# UNITED STATES PATENT AND TRADEMARK OFFICE

**Office Action Summary**

10/511,070

JONES, STEVEN VICTOR

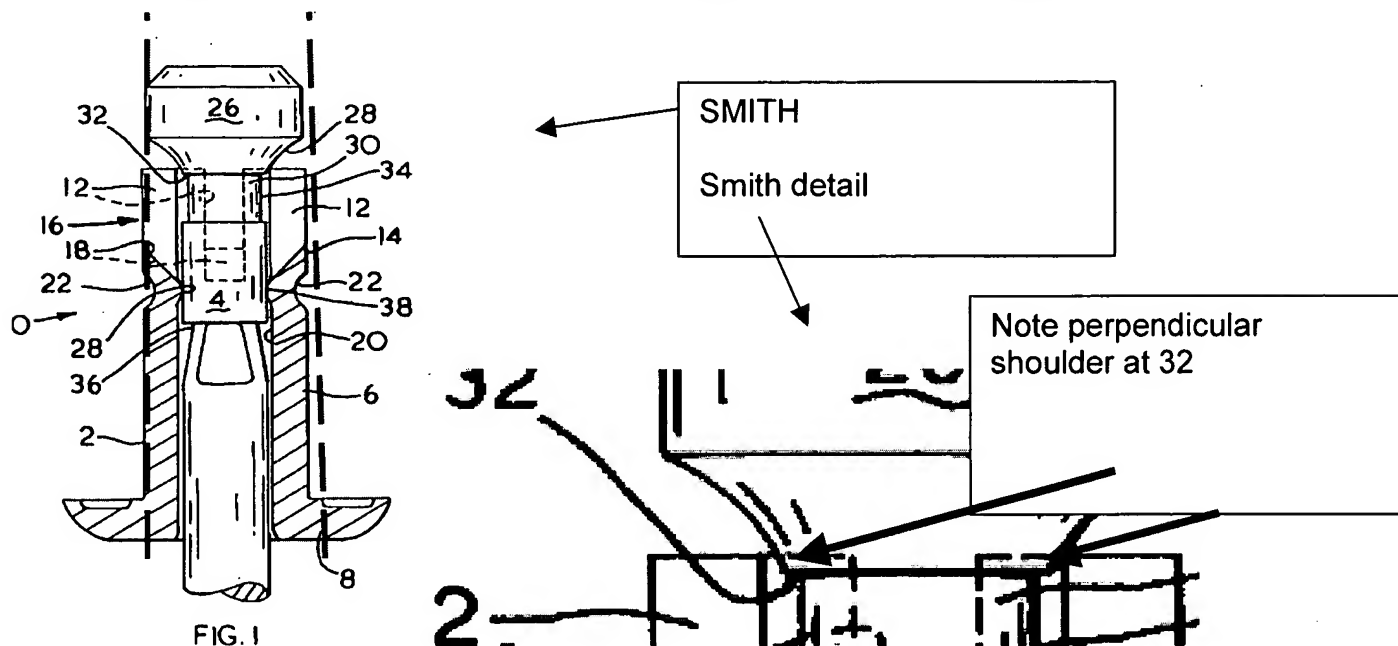
and stem (30,4, Fig 2). The head 26 has a shoulder portion (area of head above "26" extending to include surface "32" is all considered the shoulder – that is, the shoulder is the tapered portion at "28' AND the portion 32 perpendicular to said mandrel stem (Fig 1 below), wherein the shoulder portion is in contact with the opposed end (portion of shoulder at 28 is in contact with opposed end per blown up detail below) AND the shoulder 28/32 also defines a bearing surface (the portion at 32 is the defined bearing surface that is substantially perpendicular to the stem). The maximum head diameter is greater than the ID of the body (page 5 lines 9-11). The said stem has a first cylindrical portion (at 30, Fig 2) adjacent the head having a first generally constant diameter and a second cylindrical portion (at 4, Fig 2) having a second constant diameter greater than the first constant diameter.

Further Re 19: The mandrel stem extends through and is co-axial with said tubular body (Fig 1). The mandrel has a first portion (at 30) disposed adjacent the shoulder, said 1<sup>st</sup> portion defining a cylindrical surface having a generally constant diameter.

Re claim 20: Breakneck 36 defines 3 angled surfaces, (see Fig 1 and compare to applicant's "136' in Fig 3).

Re 2,13: The opposed end of the shank presents a flat surface (end of "12") perpendicular to said shank axis in Fig 1.

Re claims 3 and 6, 14 and 17: Looking at the slope of the bottom edge of the groove, identified as 18 in Fig 1, it is clear the slot increases in length as it extends from an outer surface to an inner surface. (see also page 3 lines 7-10 and page 6 lines 1-4)

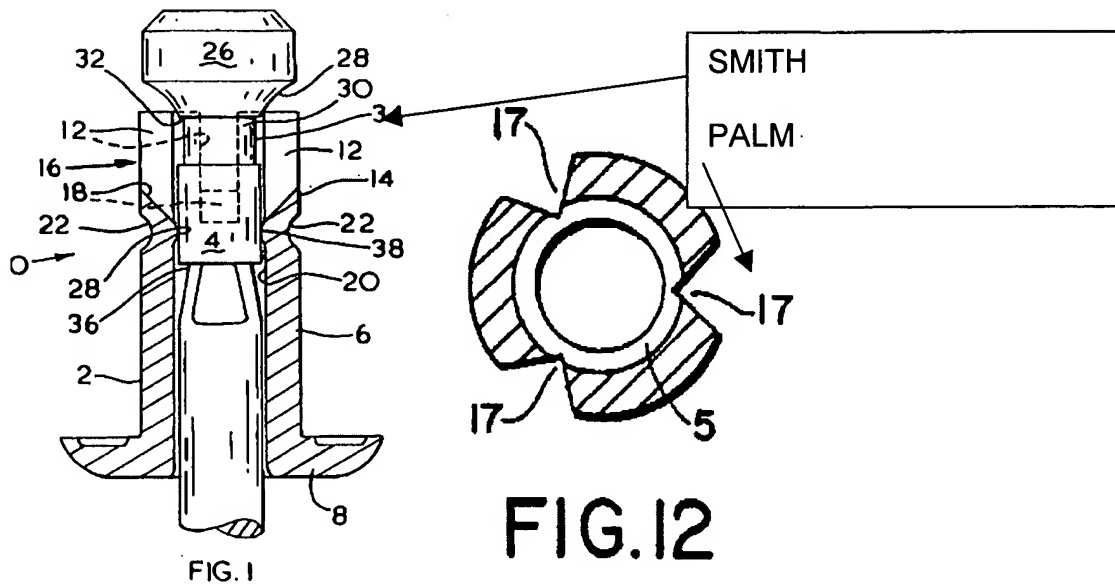
Re claim 7-8,18: Fig 1 shows constant thickness of walls along axial length, and that the external diameter of the body is constant along its axial length

Re claim 10: Fig 1 above shows the maximum diameter of the head equal to the OD of the shank.
